TPS568215 Data Sheet description

Figure 29. Loop Response, I_{OUT} = 6 A

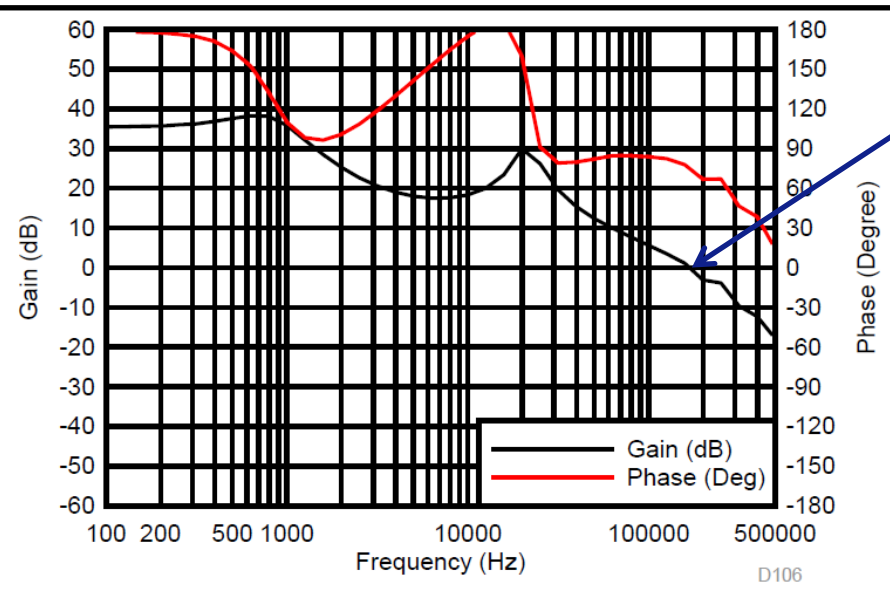
Loop bandwidth：170kHz

Time ：1/ Loop bandwidth
=5.86μs

Figure 40. Transient Response

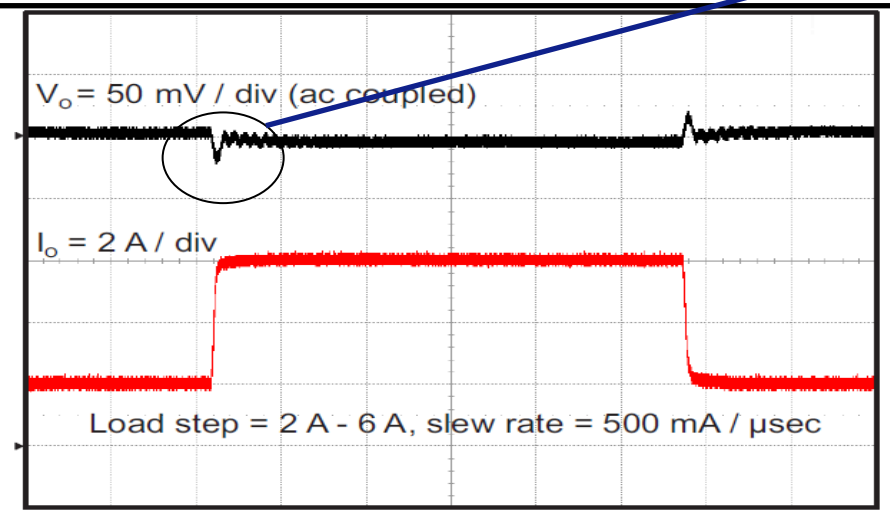
Transient Response Time：20μs

If Transient Response time is 20μs,

Loop Response is 50kHz.
Why different?
What internal control have?

Figure 29. Loop Response, I_{OUT} = 6 A

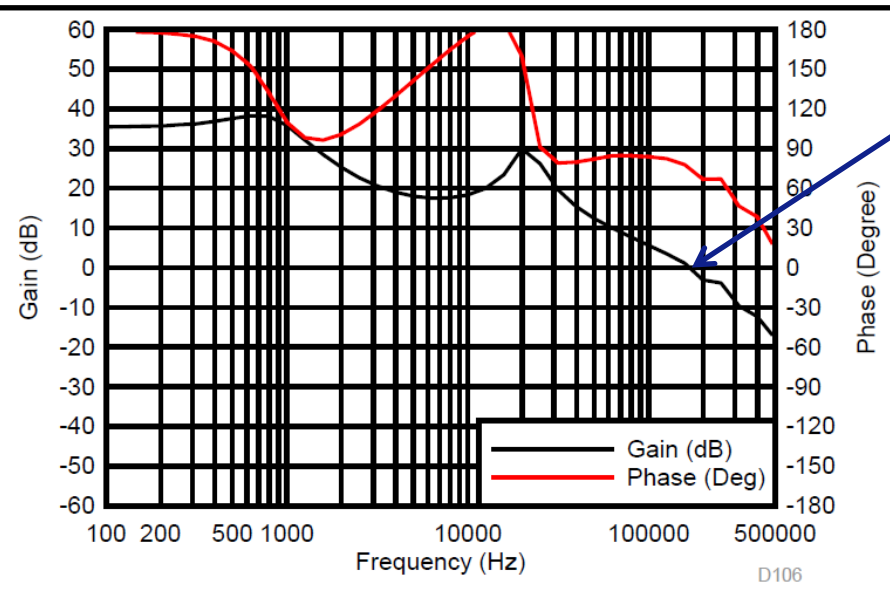
Loop bandwidth fc：170kHz

$$Tp = 1/4 \times fc$$
$$= 1.47\mu s$$

Figure 40. Transient Response

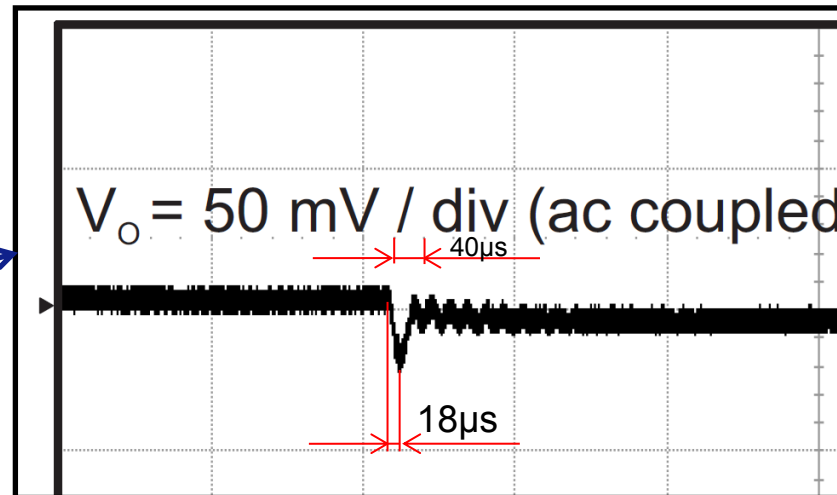
Transient Response Time Tp：18μs

Tp is 1.47μs from Loop response.
Tp is 18μs from Transient Response.
Why different?

Do D-CAP3 have Duty-cycle limiting?
